Broxwood View, 29 St Edmunds Terrace, London, NW8 7QH  
Planning application ref: 2018/0645/P  
Appeal reference: APP/X5210/W/19/3240401

Re: Discharge of Condition 16 \_ Roof Feasibility Assessment

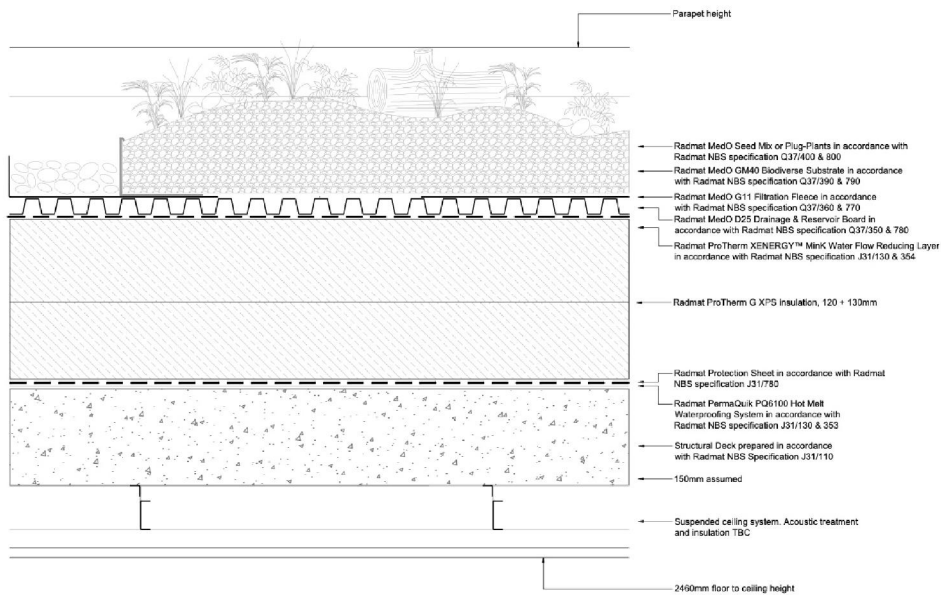
*The PV's shown on the roof cover a large area of the roof and will require regular maintenance. They will also cast continuous shadow beneath them and shadow around them as the sun moves overhead.*

*There is a large screened area for plant which again casts shadow.*

*Clearly inside the screening will be M & E equipment which would requires maintenance and would likely be ballasted or paved. There is a lift overrun and a roof access hatch which further encroach on the space available on the roof. Foot traffic across the roofs for maintenance of the PV's and M & E plant would be best achieved by designated routes.*

*As you are aware green roofs require a fire barrier gravel / ballast margin of between 300 – 500 mm width around all perimeters and obstacles, such as the parapet wall, lift overrun, access hatch, mansafe posts, any penetrations etc.*

On this basis neither a green roof or a blue roof system is considered appropriate for the higher level roof area owing to several factors:

- The use of the roof area for plant and solar panels, plus lift overrun, and access being required for maintenance resulting in minimal areas available for a green roof;
- Use of a blue roof system was not anticipated in the consented design and inclusion of one would force a redesign of the structure of the building, plus additional associated construction costs;
- Attenuation is being provided under the proposed car park which surface water will be discharged into before being released into the sewer system;

Therefore, it is proposed to use a paved roof system on the higher level roof as this better suits the purpose for location of plant equipment and solar panels and allows for safe access and use by maintenance personnel.
